UNITED STATES
NUCLEAR REGULATORY COMMISSION
REGION IV
1600 EAST LAMAR BLVD
ARLINGTON, TEXAS 76011-4511

Subject: FORT CALHOUN STATION – NRC SPECIAL INSPECTION REPORT
05000285/2013-012

U.S. NUCLEAR REGULATORY COMMISSION

Report: 05000285/2013-012

Figure 1 - DWG 11405-S-312 "design" drawing

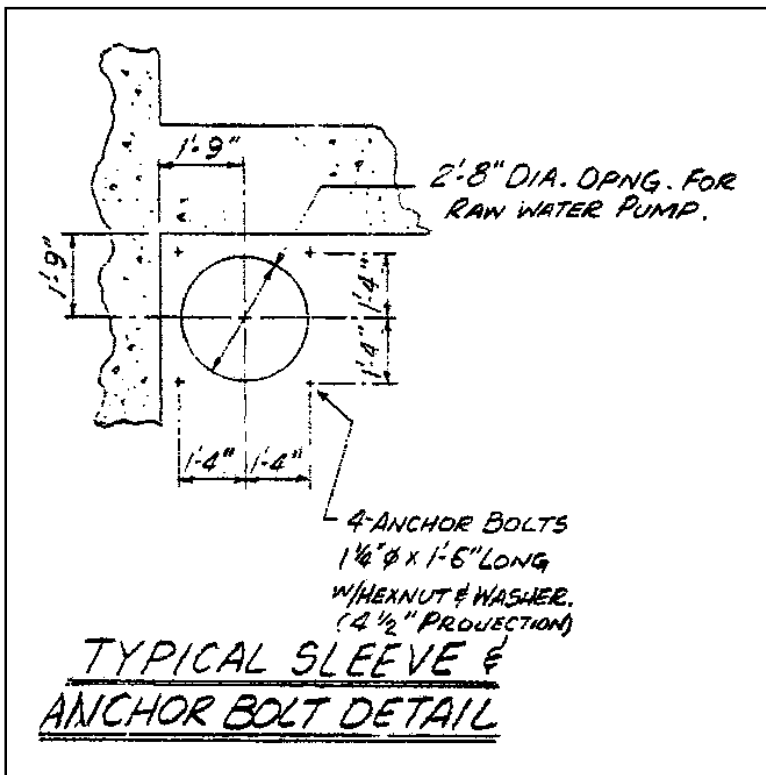
The design drawing 11405-S-312, as shown in Figure 1, did not contain sufficient information about the anchor bolt details or potential interferences.

1969	Fort Calhoun Station design drawing 11405-S-312 specifies 18 inch anchor bolts with hexnuts and washers for the raw water pumps are "Typical sleeve & anchor bolt detail." Engineering personnel interpreted this to mean a cast-in-place Type II (headed stud) anchor bolt.
July 1, 1969	"Shop" drawing number 154 specifies "ABL-154" markings for Type I (J-style) anchor bolts.
July 10, 1969	"Pour" drawing 7908-C specifies ABL-154 anchor bolts to secure the raw water pumps.
February 19, 1987	NRC issues Generic Letter 87-02 "Verification of Seismic Adequacy of Mechanical and Electrical Equipment in Operating Reactors (USI A-46)."

- October 28, 1993 OPPD SQUG engineers complete analysis for the raw water pump anchor bolts to respond to Generic Letter 87-02.
- The raw water pump anchor bolt SQUG calculation used design drawing 11405-S-312 as the only input, and incorrectly assumed the anchor bolts were Type II (headed stud).

Figure 2 - DWG 154 "shop" drawing

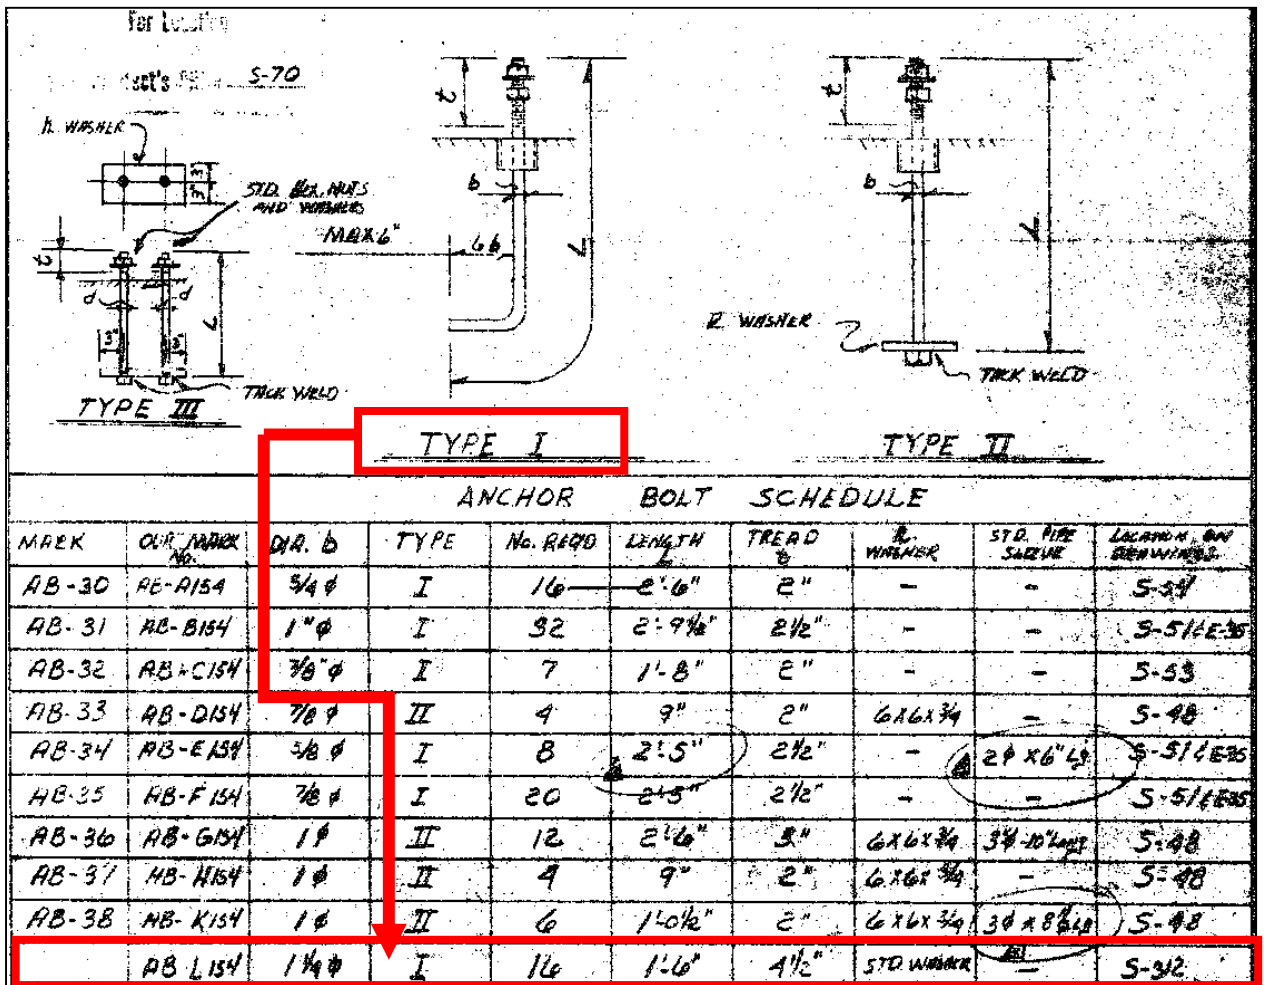
The engineer then referred to "shop" drawing Number 154 (Figure 2) and the construction "pour" Drawing 7908-C (Figure 3).

After reviewing the drawings, the system engineer did not expect that the shop drawing (Figure 2) would specify a Type I, or J-bolt. The J-bolt anchor was unexpected because station personnel assumed that the anchor bolts were Type II, or headed stud anchor bolts, based on design drawing (Figure 1). That incorrect assumption was used for the design basis of the anchor bolts. There was not an original design specification for the raw water pump anchors.

Figure 3 - DWG 7908-C "pour" drawing

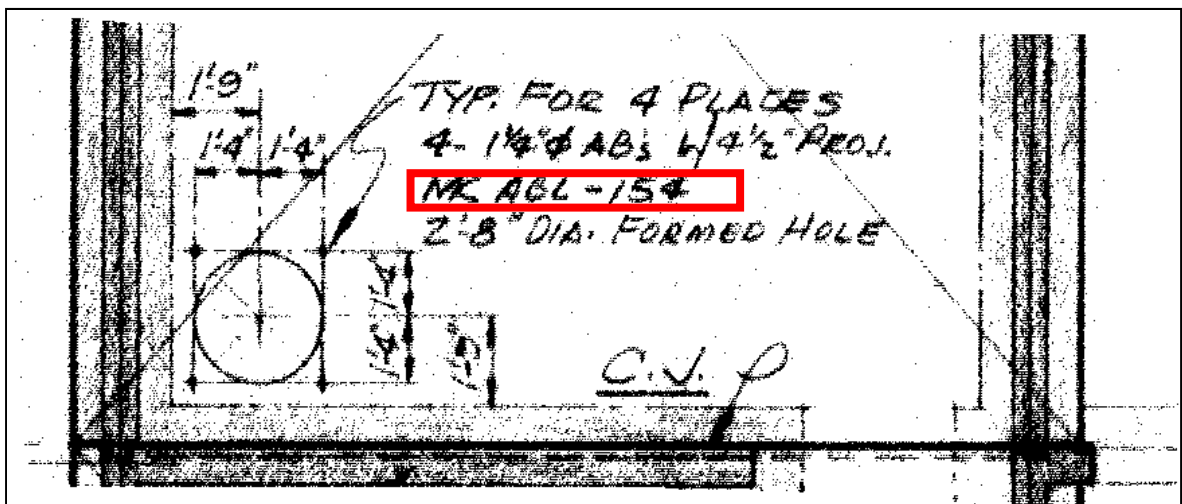
The design specification for the raw water pump motors is designated MK ABL-154 as noted in Figure 3. The corresponding anchor bolt data for an MK ABL-154 anchor bolt is found in the “schedule” shown in Figure 2. Clearly, the design specification for the anchor bolts was a Type I J-style anchor bolt.
